COMMITTEE OF THE WHOLE OCTOBER 4, 2011

SIGN VARIANCE APPLICATION FILE NO: SV.11-022 OWNER: MAJORWEST COMMERCIAL II INC. LOCATION: 3737 MAJOR MACKENZIE DRIVE LOT 20, CONCESSION 5 WARD 3

1. Site Plan and Sketch of Sign

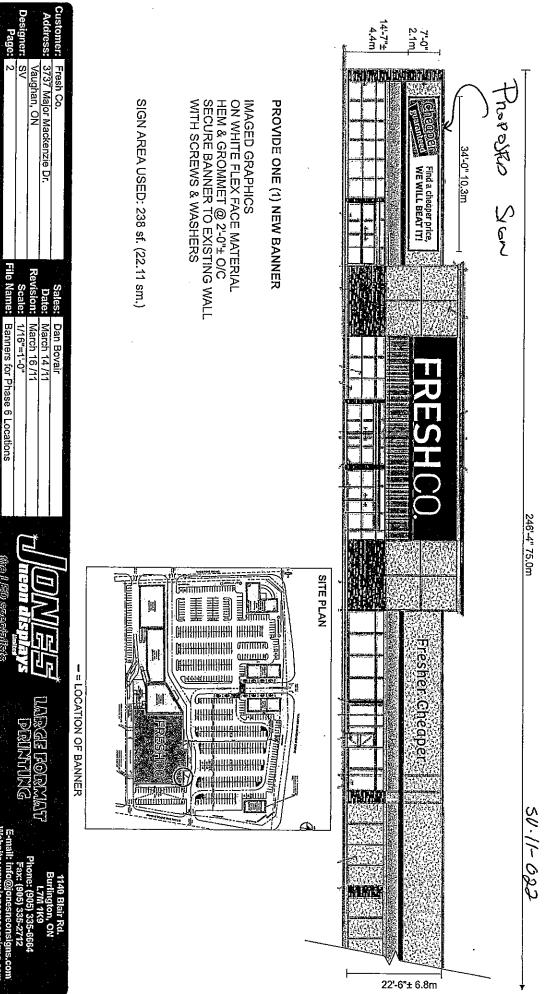
The applicant is proposing to install one additional 22.1 sqm. banner sign on the building's north elevation as shown on the attached drawings. The proposed banner sign is in addition to the two other wall signs that have been previously approved.

Members of the Sign Variance Committee do not support the application and have concerns over both the type and size of the proposed sign.

In Committee's opinion the banner type signs should not permitted as provided for in the City's Sign By-Law, and the construction of the proposed sign should be of a similar type to the signs that presently exist on the building. (e.g. cut out channel letters.)

Further, the size of the proposed sign should reduced by a minimum of 15%. (22.1 sqm. -15% = 18.7 sqm.) to be more compatible with the building's elevation.

- i) that the proposed banner type sign not be permitted;
- ii) that the proposed signage be comprised of cut out channel letters with logo signage be permitted to be within sign box (non illuminated); and
- iii) that the overall sign area be reduced by 15%.
